## **RFQ#21-28 - ADDENDUM #3**

### **Waterloo City Hall 2nd Floor Office Space Renovation**

**ADDENDUM ISSUE DATE: August 8, 2021**

Subject: **Addendum No. 03**

1 DEMO/PARTITION PLAN  
A1 SCALE: 1/8"=1'-0"

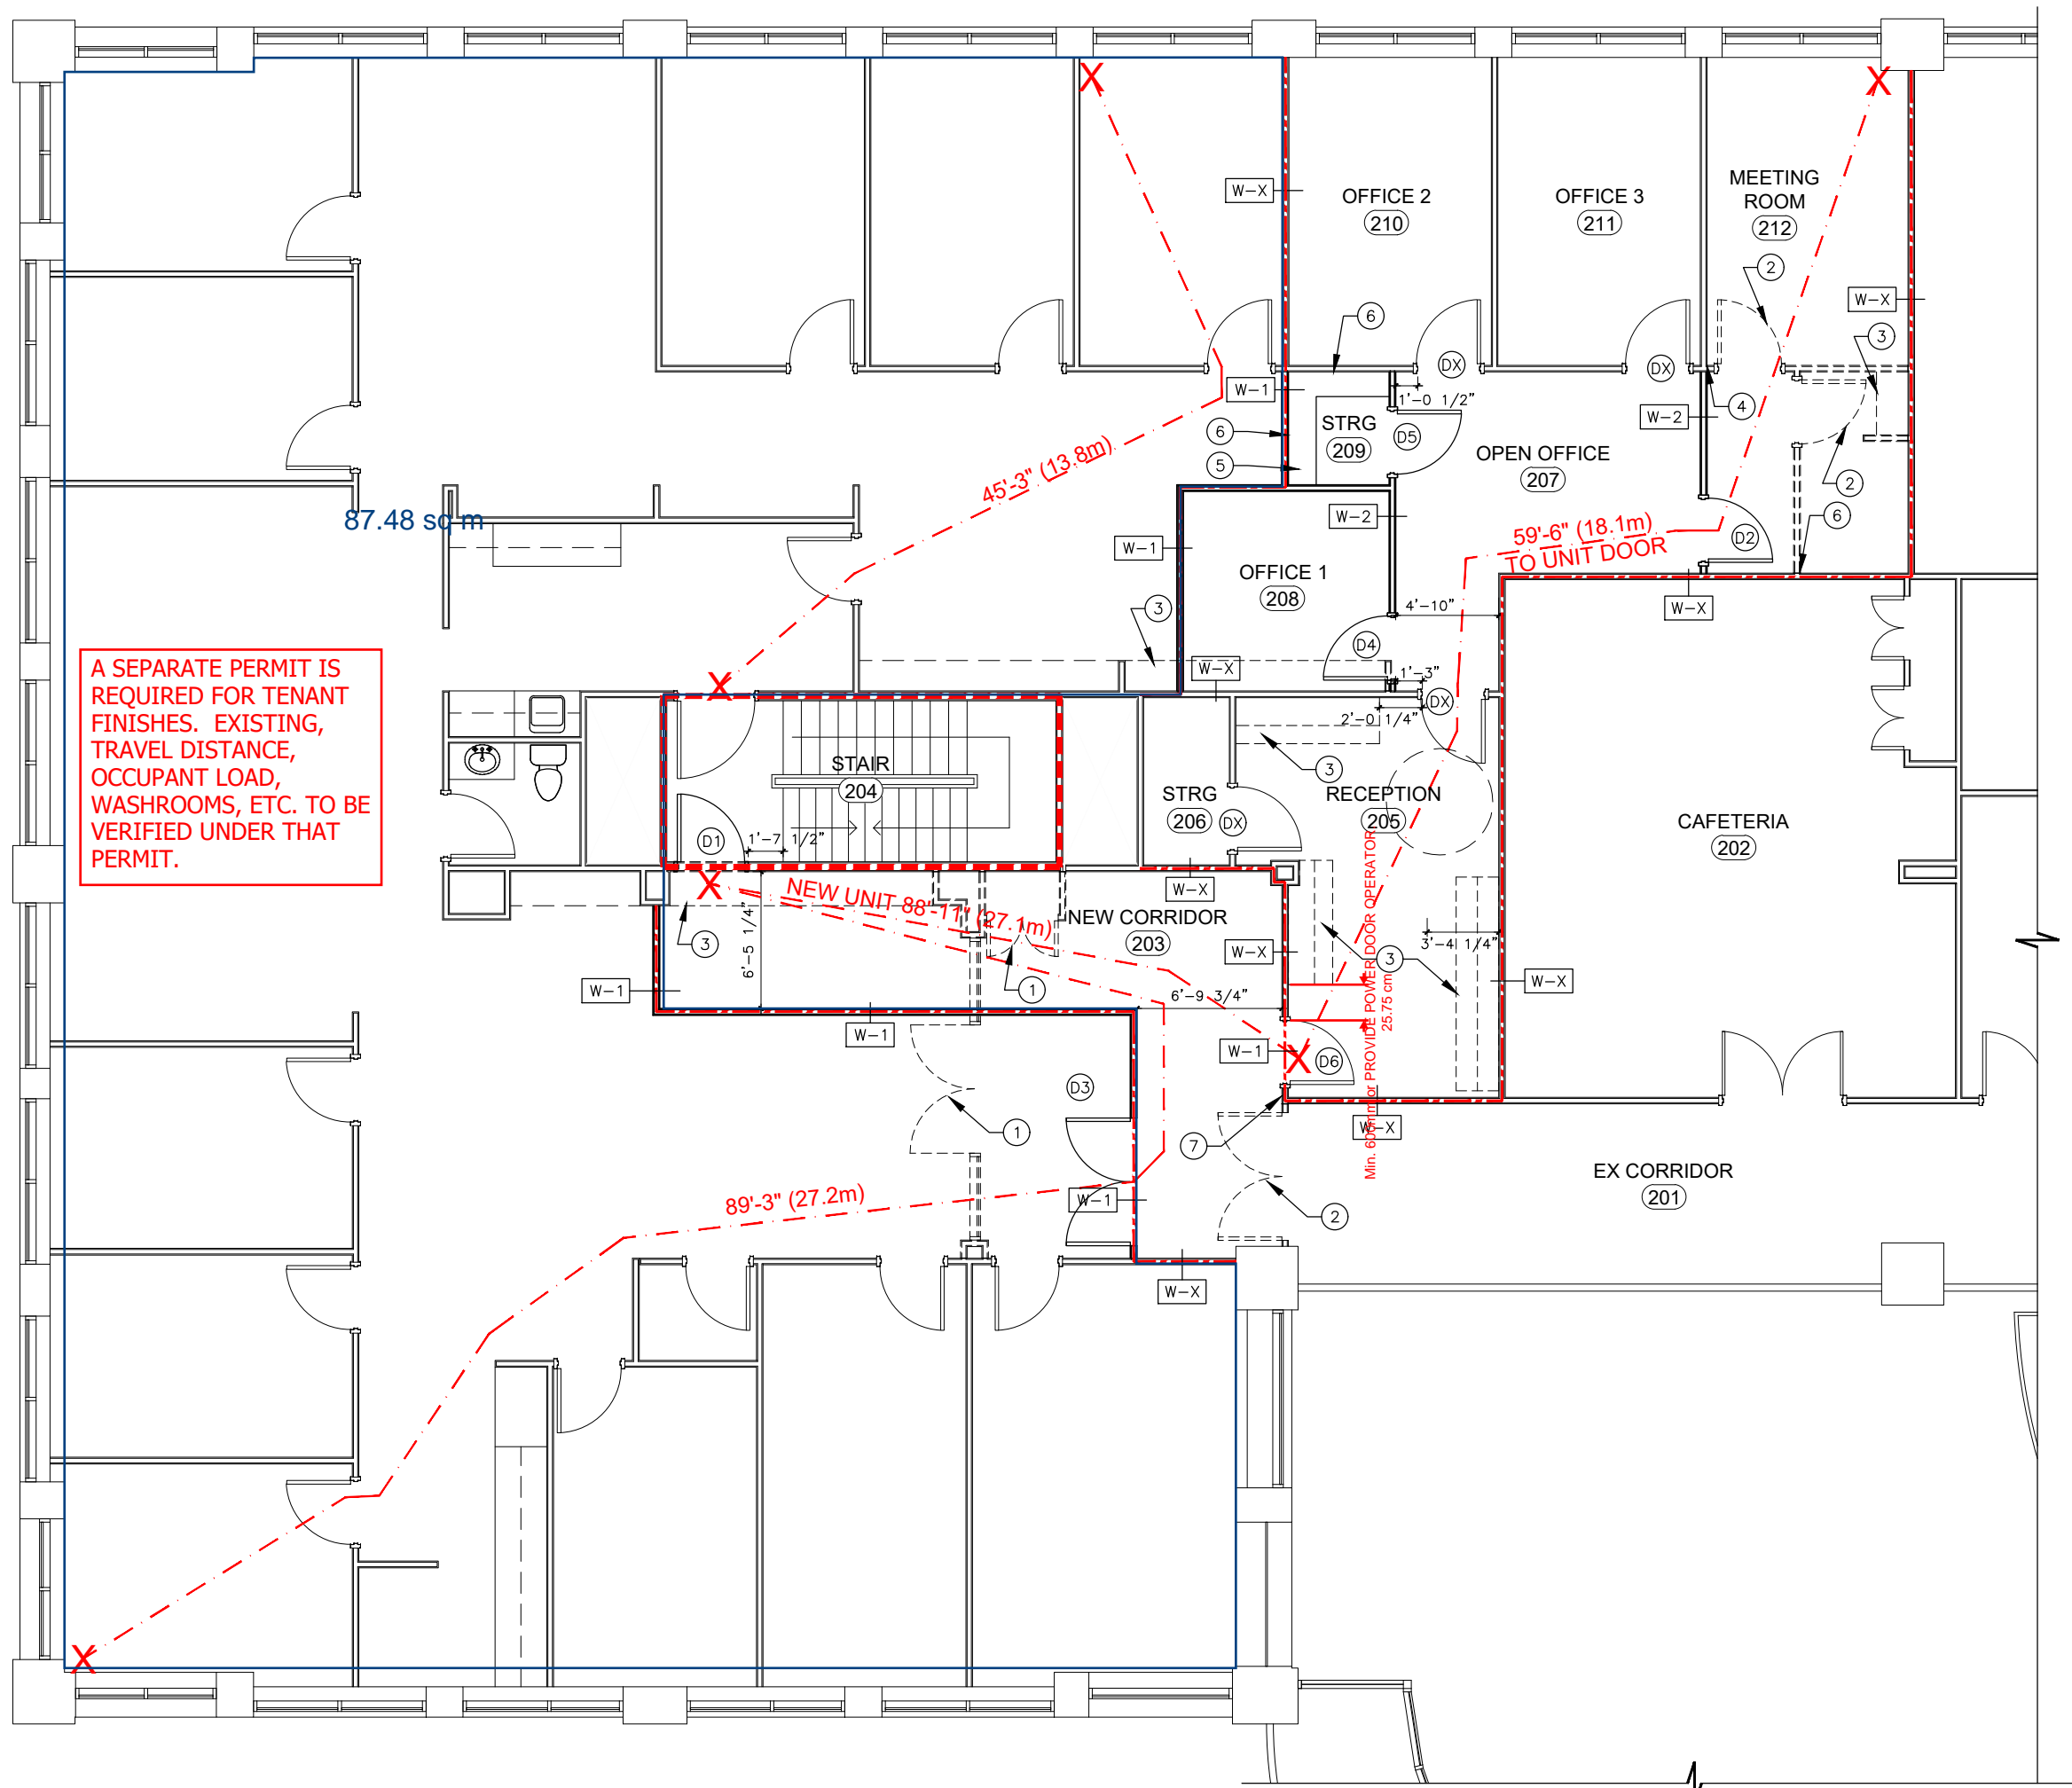
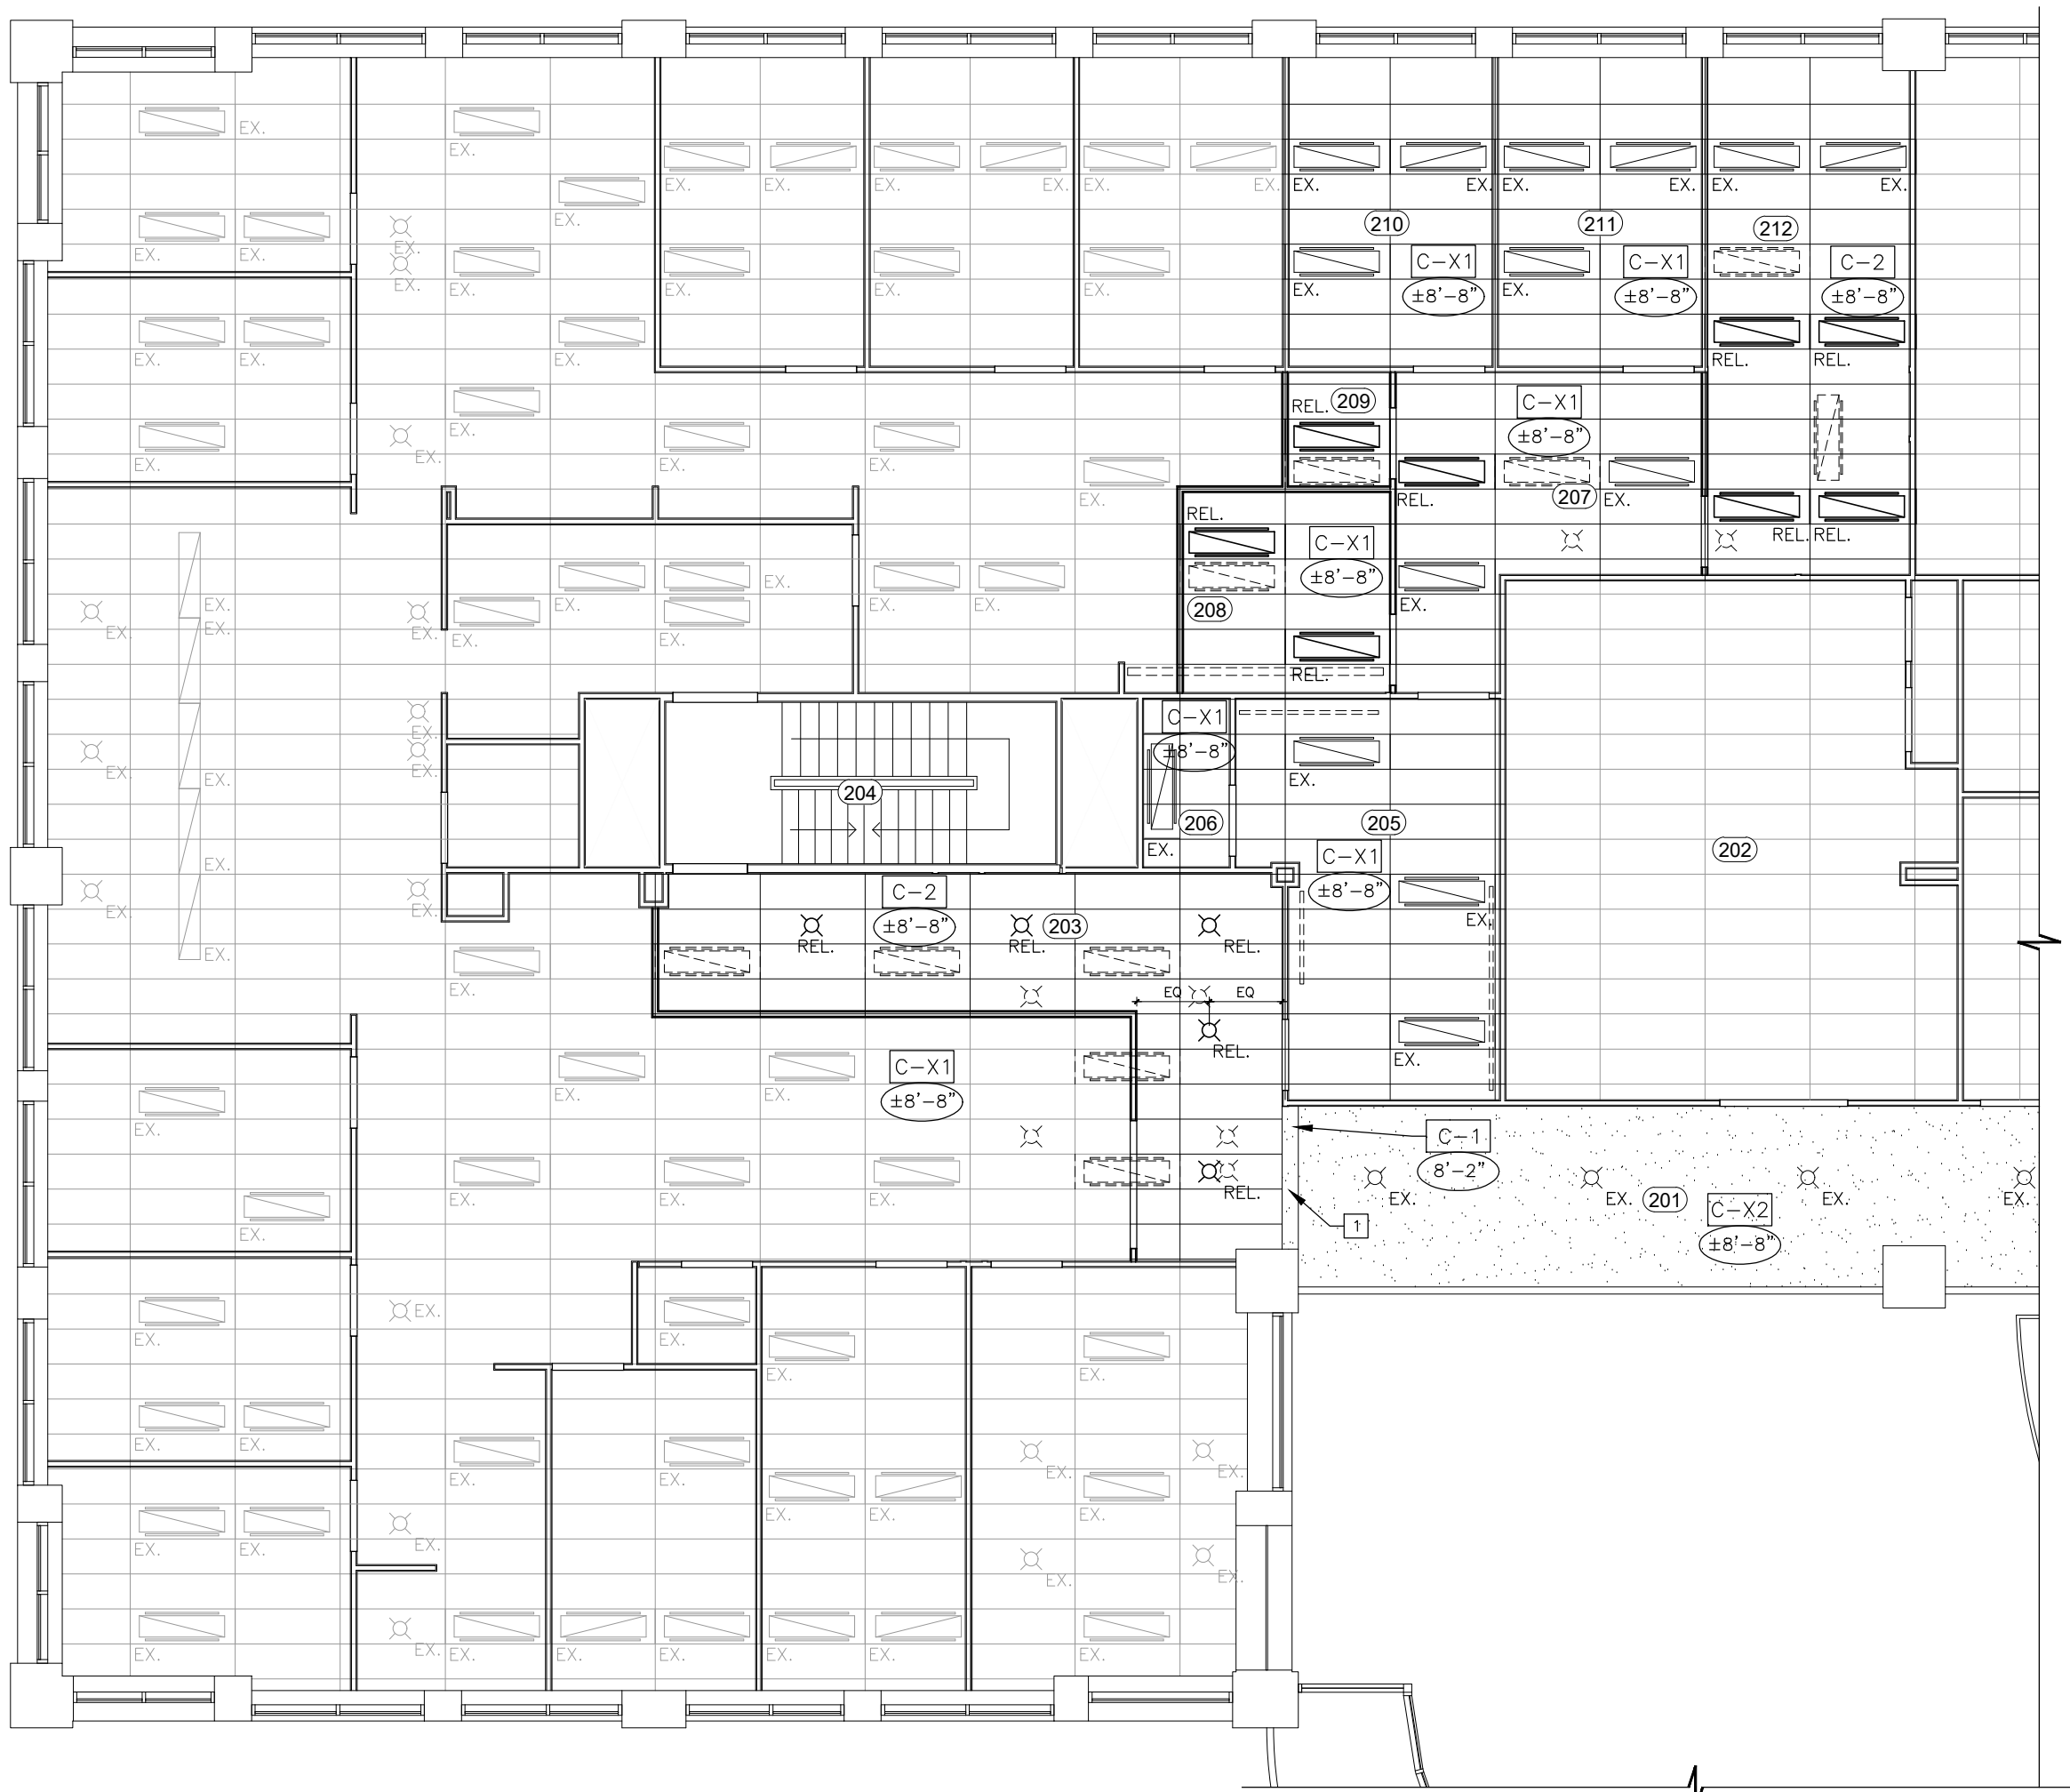
6. Contractor to include \$3,000.00 Cash Allowance for Testing to ensure smoke control and venting systems are satisfactory per OBC 3.2.8.11.(1). Refer to attached approved building permit drawings.

TESTING SHALL BE PROVIDED TO THE BUILDING INSPECTOR UPON REQUEST IN COMPLIANCE WITH 3.2.8.11.(1) TO ENSURE SMOKE CONTROL AND VENTING SYSTEMS ARE SATISFACTORY.
